Project No. VN222370

Proposed Development, Uldale View, Egremont

This Technical Note has been prepared to address highway comments from Cumberland Council received in relation to planning application 4/23/2313/0F1. The application proposes the development of 164 residential dwellings on land to the east of Uldale View in Egremont.

DRAWING NUMBER: VN222370-TR102

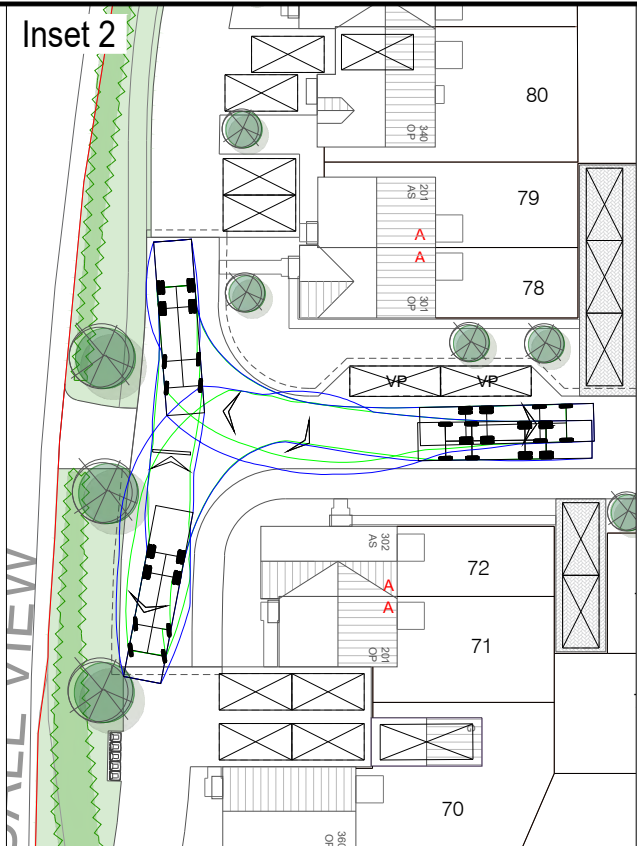
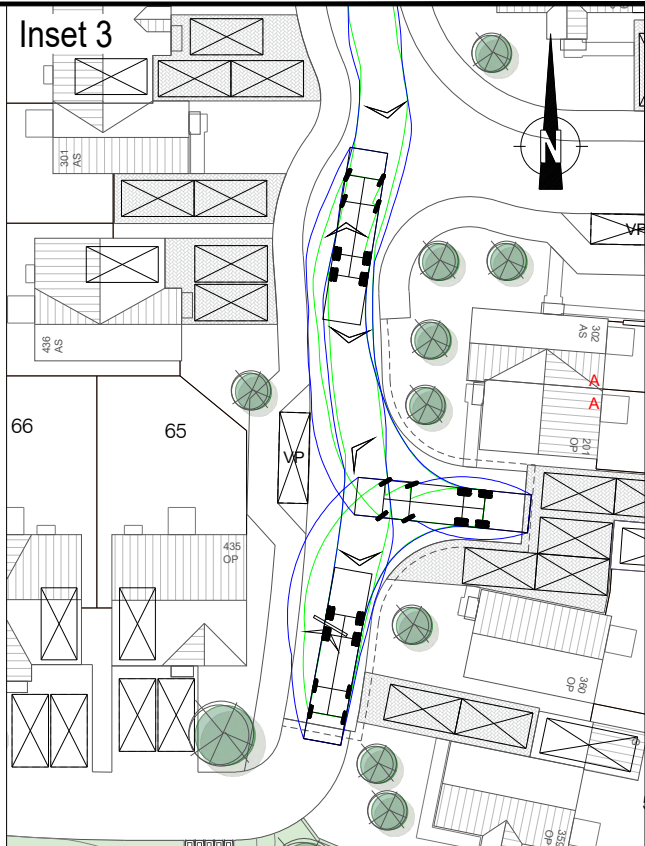
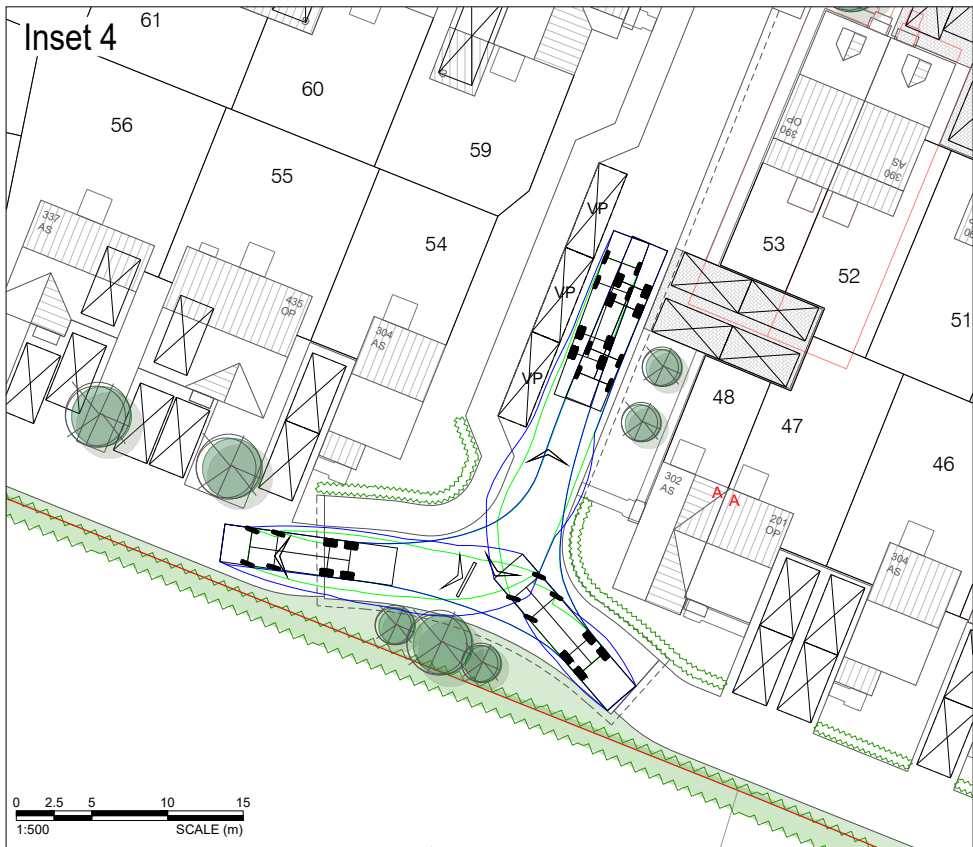
The layout should be revised to a loop road for the main road around the site. This is easily achieved with minor modifications to the layout to make a continuous road between Plots 110 and 115. This will remove significant reversing manoeuvres and the inherent danger. This main circular road should have a 2m wide footway to the west or possibly both sides of the road.

The site layout has been updated to reflect this comment, with a loop road now provided. An updated layout, 73D-MJG 100, is provided with this TN01 in **Appendix B**. For completeness an updated AutoTRACK assessment has also been prepared using an 11.5 metre refuse vehicle, as presented in VN222370-TR102 Rev A. This confirms that the revised layout can appropriately accommodate all required vehicle movements.

DRAWING NUMBER:	VN222370-D105	REVISION:	A
-----------------	---------------	-----------	---

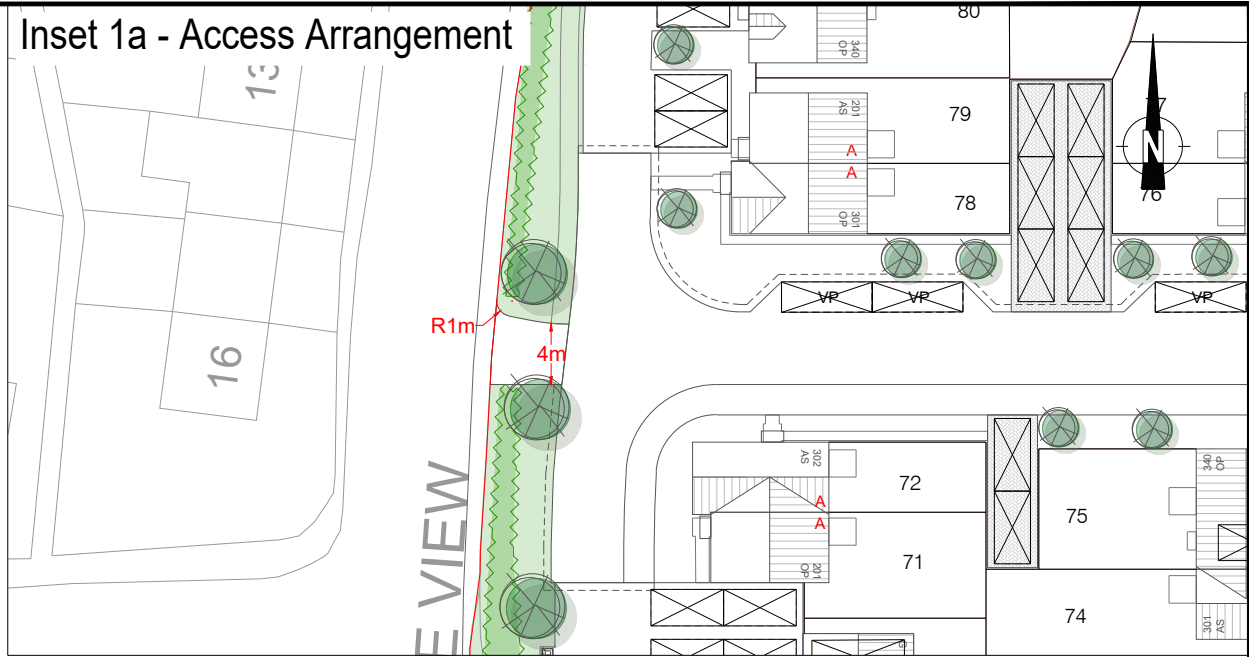
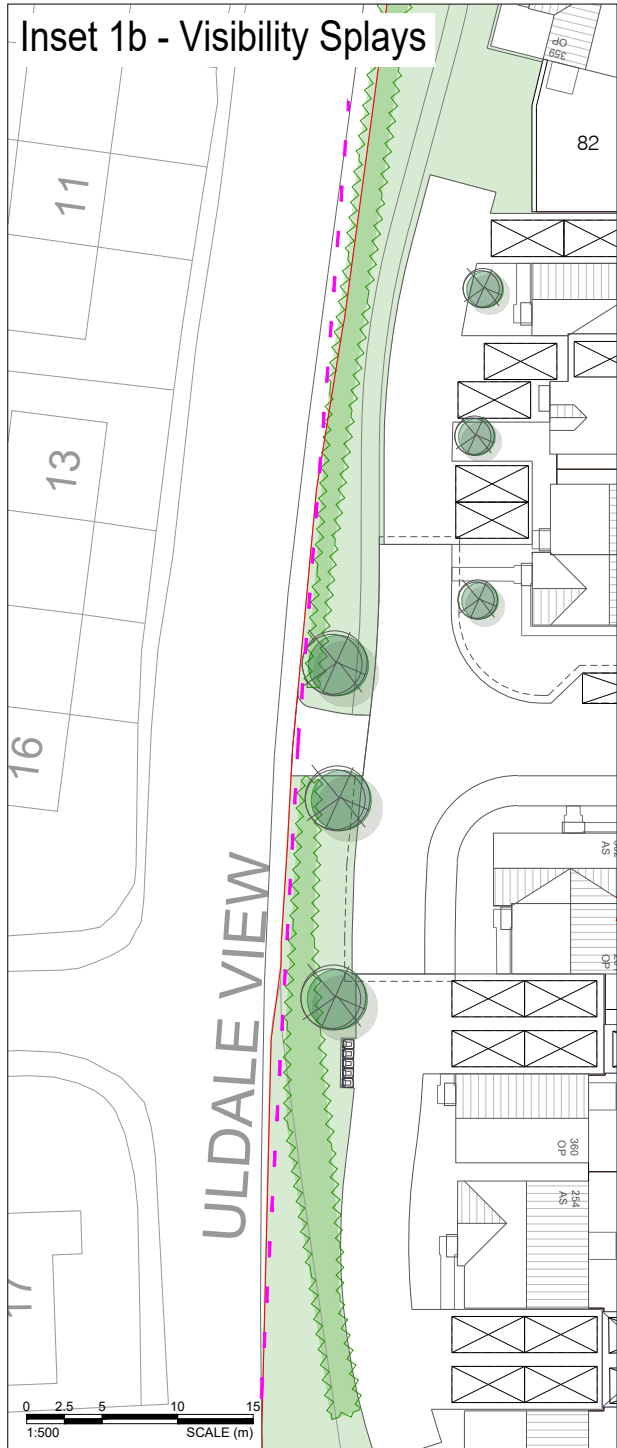
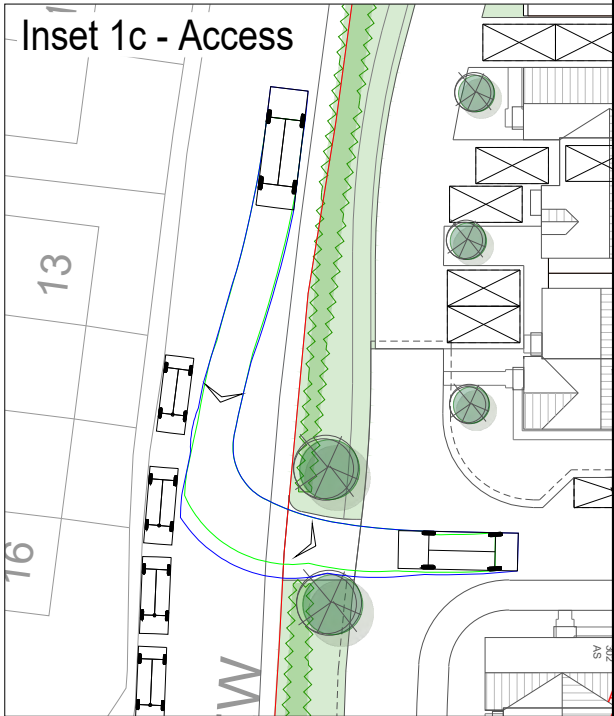
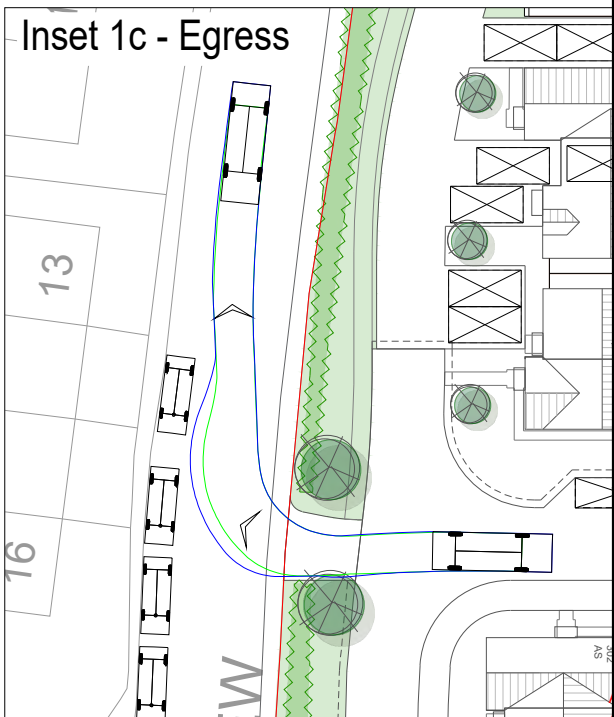
It does not appear that the necessary visibility splays from the footpath and EVA onto Uldale View can be achieved with the existing hedge in-situ. These should be 1.5 x 43m for both in each direction. The applicant is encouraged to review the arrangement and network of footways to maximise connectivity.

The design of the EVA has also been revisited. This now provides a 4 metre wide route, which exceeds the minimum 3.7 metre requirement for emergency vehicles, as outlined in the Building Regulation requirement B5 (2000)10 concerning 'Access and Facilities for them Fire Service'. Section 17, 'Vehicle Access'.

The revised EVA has been tracked using a fire tender vehicle, and assuming that cars are parked on the western side of Uldale View. This is presented in plan VN222370-D105 Rev A which is provided in **Appendix C**. The plan also confirms that visibility splays of 1.5 metres x 43 metres are achievable at the access, achieved by a proposed minor amendment to the hedgerow alignment.

DRAWING NUMBER: VN222370-D104 REVISION: A

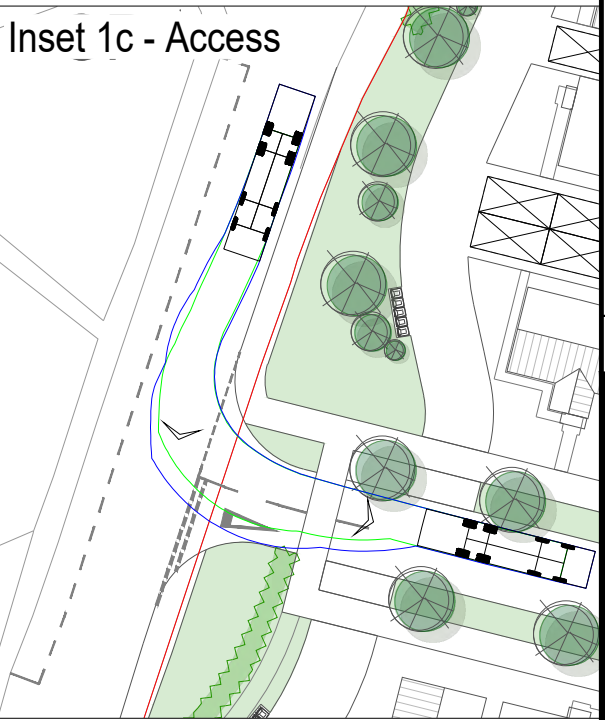
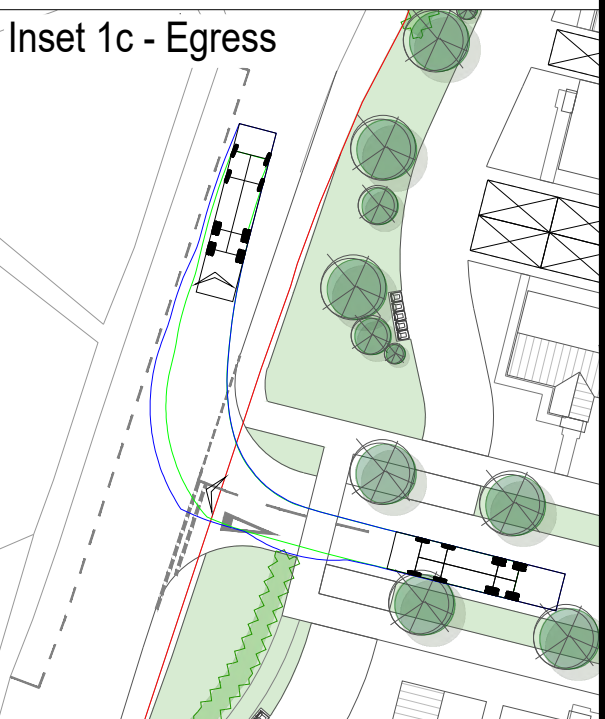
The main site access onto Uldale View comes out where vehicles are typically parked on the west side of the road. This will create an awkward manoeuvre (i.e. a single lane road effectively for emerging traffic). Consideration should be given to moving this access further north and / or providing some localised widening to accommodate 2-way traffic + a row of parked cars on Uldale View.

The design of the main site access has now been revisited. In accordance with the Council's requirements the access now allows for a 2 metre zone on the western side of the carriageway to allow for the presence of parked vehicles, with the residual road space on Uldale View widened to ensure a minimum 5.5 metres of available carriageway between the site access and the junction with Bookwell. The footway running north of the access towards Bookwell has also been widened to 2 metre.

The updated general arrangement layout is provided in Drawing VN222370-D104 Rev A which is included in **Appendix D**. The drawing includes a tracking assessment of the revised layout using an 11.5m refuse vehicle.
